STATE OF NORTH CAROLINA
DEPARTMENT OF TRANSPORTATION

MEMORANDUM TO: Roadway Project Engineers

SUBJECT: Ditches with Stone Liner

Drawing Is Not to Scale

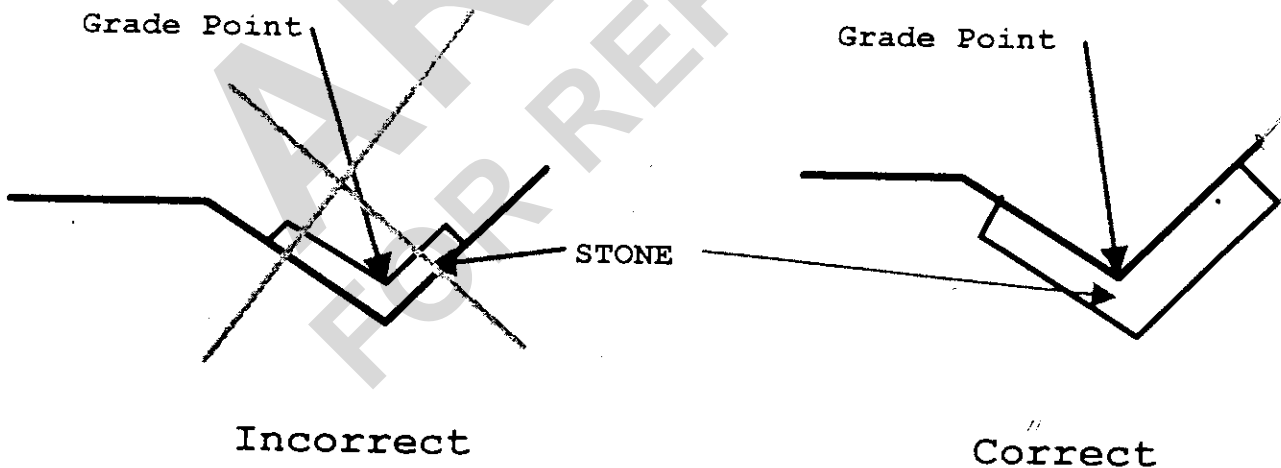
It has come to my attention that we (Roadway & Hydraulics) are showing ditches with Stone liner on the cross sections by at least two different methods. The purpose of this memo is to document the correct method.

Through discussions with David Henderson of Hydraulics, Steve Dewitt of Construction, and Gary Lee of Design Services, we have agreed on the proper way to show and compute the Drainage Ditch Excavation quantity. Below you will see drawings reflecting the most common incorrect method and the actual correct method of Stone placement. Stone will not be shown on the cross-sections.

Excavation for the Stone is incidental to the pay item for the Stone. The new criteria library being developed will reflect the proper grade design and compute the appropriate DDE quantity.
